**From:** Benoit, James D. [mailto:BenoitJD2@bv.com]  
**Sent:** Friday, June 25, 2010 3:54 PM  
**To:** KATE RUDACILLE; Siebentritt, Heidi; McConnell, Kate  
**Cc:** Doran, Daron; Sinclair, Keith; Tuttle, Robert G.; James K. Sillers; Barry Lucas  
**Subject:** PILTOA-VA, Site 46 Proposed Architectural Revisions

Please see attached Architectural Elevation drawing of Site 46 in Loudoun County and additional specifications for stone.

**From:** McConnell, Kate  
**Sent:** Wednesday, June 30, 2010 11:45 AM  
**To:** Benoit, James D.; KATE RUDACILLE  
**Cc:** Siebentritt, Heidi; Tuttle, Robert G.; Sinclair, Keith; Barry Lucas  
**Subject:** RE: PILTOA-VA, Site 46 Proposed Architectural Revisions

**SOUTH ELEVATION**  
SCALE 1/8"=1'-0"

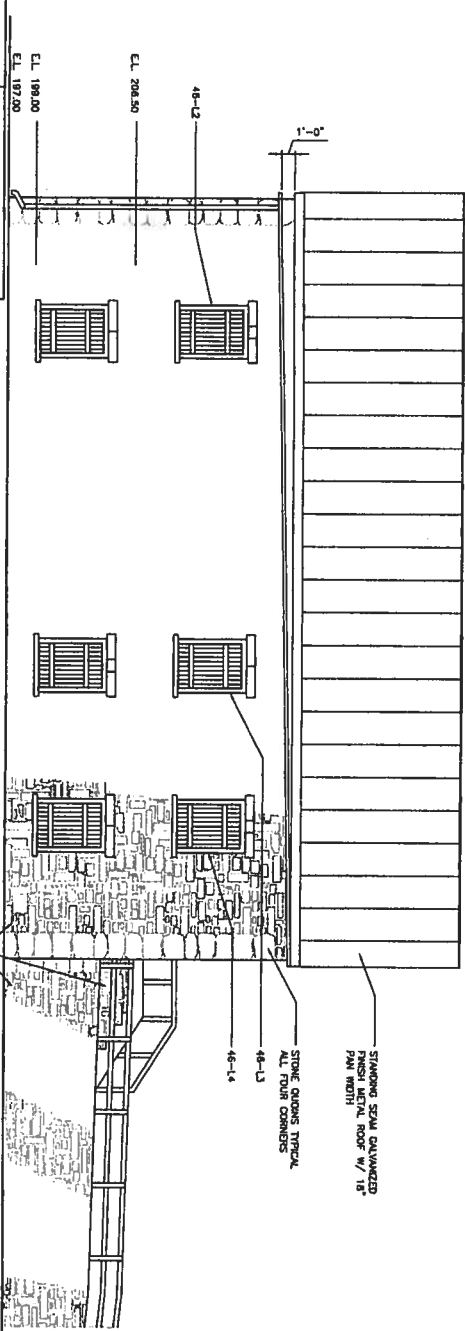
1. Elimination of the chimney and relocation of exhaust port to North (back) wall.  
**No comment –this is fine.**
2. Clarification of roof pan width to 28" and surface appearance to galvanized steel.

**The plans state 18", which is the appropriate pan width.**
3. Deletion of two downspouts from South (front) side, and use of semi-circular gutters and circular downspouts.

**Typically, the gutters are described as half round gutters and round downspouts.**
4. Addition of 24"w X 12"h quoins (corner stones) to the four building corners.

**The quoins do not have to be 24" by 12"...this was an example provided by the stone mason. Instead, the quoins will be larger stones, but randomly shaped depending on what is available in the stones delivered to the site.**

5. Revision of description of building & ramp facing rock to "Field Stone set in mortar, random size and shape, set in mosaic pattern".  
**There is no need to state, "set in mosaic pattern," as the randomness of the stones will create the "pattern" (or lack thereof).**

**Instead of painting the door to be something that it is not, Heidi and I suggest painting the door a neutral dark color that blends into the background and/or does not allow the shadow of the door sections to be easily seen when passing by.**

**The window sills should have more definition. In other words, the ends of the sill should project beyond the base of the window frame, as well as from the front of the building, to be in keeping with historic building techniques. Please refer to the images that I sent in the past.**

1. Elimination of the chimney and relocation of exhaust port to North (back) wall.
2. Clarification of roof pan width to 28" and surface appearance to galvanized steel.

3. Deletion of two downspouts from South (front) side, and use of semi-circular gutters and circular downspouts.
4. Addition of 24"w X 12"h quoins (corner stones) to the four building corners.

5. Revision of description of building & ramp facing rock to "Field Stone set in mortar, random size and shape, set in mosaic pattern".
6. Adoption of additional language for inclusion in Specification Sections 04110 - "Mortar and Masonry Accessories" and 04410 - "Stone Masonry Veneer". Language to specify materials and methods for the use of stone, mortar, etc developed with local stone masons/vendors known to be in concurrence with Loudoun County Historic Guidelines for new construction. Local vendors to be called out in specification sections for approved sources.

**NORTH ELEVATION**  
SCALE 1/8"=1'-0"

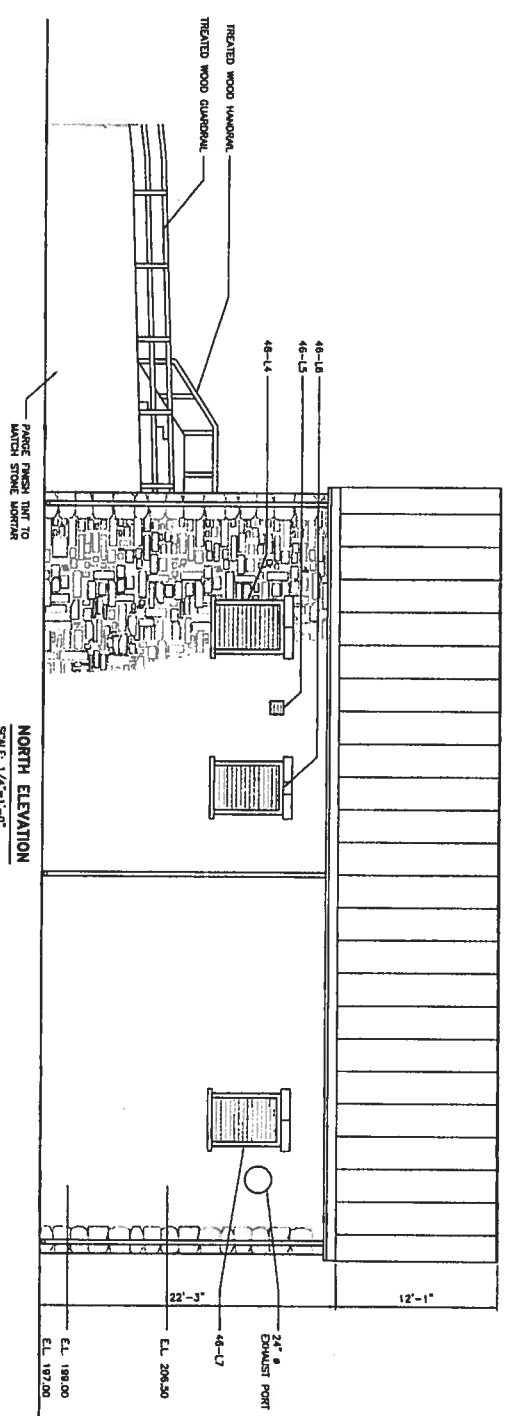
Heidi and I believe that tinted parging on the rear of the ramp would be acceptable since it won't be seen by the public. Regarding roof, leaving the roof galvanized (not painted) was/is common for ag buildings and is more reflective than most colors (shades of white being the main exception).

2. Will the back wall of the ramp (the north elevation) have any treatment? Perhaps stucco instead of stone? If this is acceptable it would be more economical. We could tint the plaster to match/compliment the stone. I would suggest the buttress motif be continued.

3. Can the 24" exhaust vent on the north elevation (taking the place of the chimney vent) be a square louvered vent instead of round? Similar to those in the top and bottom photos on the Stone Utilitarian Buildings attachment. Does that exhaust structure protrude from the wall? Our current intent is to have the top of the round exhaust project outside the wall and bevel back like a cap.

Upon discussion with Heidi, we do not believe that the stone buttresses are necessary to add visual interest to the retaining wall. A skillfully laid stone wall will be visually interesting in its own right as I suggested last week. Still, if the buttresses are desired, then they should be constructed of randomly sized stones, just as the wall (and quoins). It would be strange to add a element with identical stones to the wall made of randomly shaped stones. Also, I would suggest showing a detailed profile of the top of the proposed buttresses so that this element can be more fully reviewed and clearly conceptualized.

**Are you referring to the north elevation here? If so, then is it necessary to include the lower row of windows? If this is not visible from the road, then Heidi and I agree that it wouldn't be necessary to mix the elements/window types on the rear.**

7. Addition of six, 12" X 12" equally-spaced buttresses to north and south sides of ramp concrete retaining wall, with beveled capstones.
8. Facing of South (front) ramp concrete retaining wall with Field Stone, and North (back) concrete retaining wall with parge finish, tinted to match rock mortar.
9. Revision of stair handrail to match treated wood ramp guardrail.
10. Provision of four faux widow treatments for illustration and **requesting direction on their application.**  
**Please advise.**
11. Showing proposed window treatment for the three large and one small louvered windows on the upper South (back) south side
11. Provision of two variation of window lintels with intent to use one or the other on all windows.
12. Clarification of finish on roll-up door to be painted to match wood pattern windows.

**EAST ELEVATION**  
SCALE: 1/4"=1'-0"

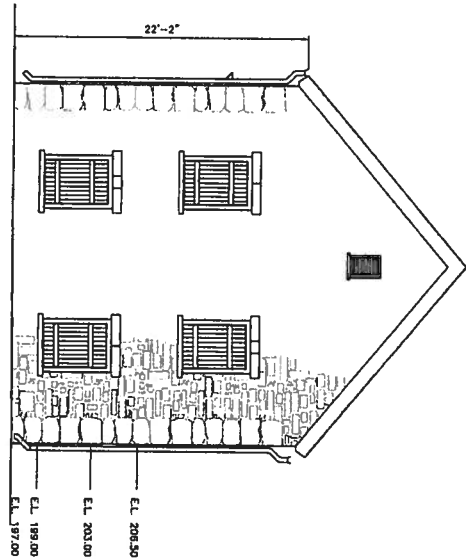
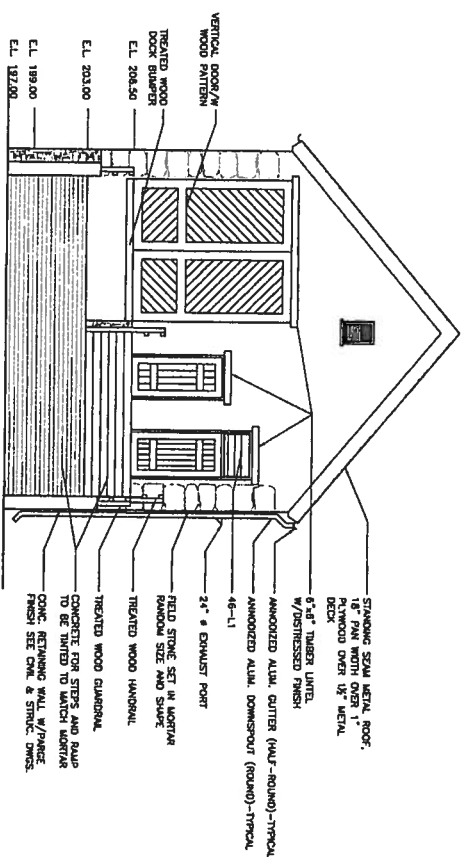
In looking at the elevations again, I noticed that there are no lintels above the doors in the gable end. These openings should have lintels too. Since the garage door is so wide, an large timber lintel may be best (or necessary) for this opening.

**Also, the openings in the gable peak could be smaller and use wood louvers which is typical of smaller openings. As smaller opening would likely have a different lintel as well. I'd have to research this more if you go with a smaller opening.**
